## LiFT Pack S-Series Technical Bulletin

### **SUBJECT:** Positively Charged Case

Bulletin No.: TB1-2017

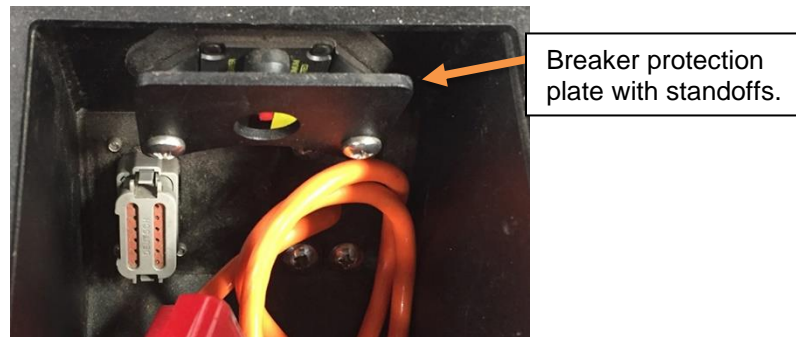
The pack arcs with the truck chassis, the main fuse blows or the breaker pops.

The bolts used to mount the breaker are longer than necessary and create a risk of contact internally with the lugs bolted to the breaker. If they come in contact, over time the insulation may wear through creating contact between the positive battery lead and the breaker bolt, energizing the battery case. This issue increases the possibility of a blown fuse, and may effect truck operation if the truck chassis is tied to battery ground (battery negative).

UL Listed LiFT Packs with serial numbers 160011-160345 are susceptible unless they have the breaker protection plate with standoffs located in the cable storage box and pictured below.

All LiFT Packs in stock or in for service should have the bolts replaced or cut to the appropriate size. Use the following instructions when implementing this fix.

**Repair:** All LiFT Packs brought in for service should have the bolts replaced or cut using a bolt cutter. To cut or replace the bolts,

1. Press the red breaker button to turn off the battery
2. Remove the 16 lid bolts, lift the lid off the battery and rest it on the side of the battery case.
3. Remove the two lugs/nuts on the back of the breaker, tape the lugs to prevent arcing.
4. Remove the nuts holding the breaker to the battery lid.
5. Cut the bolts to the appropriate size, or replace them with bolts that are 10-32 7/8".
6. Tighten nuts back onto bolts.
7. Apply silicon rubber around the back of the breaker if the pack is going to be put in a power washing environment.
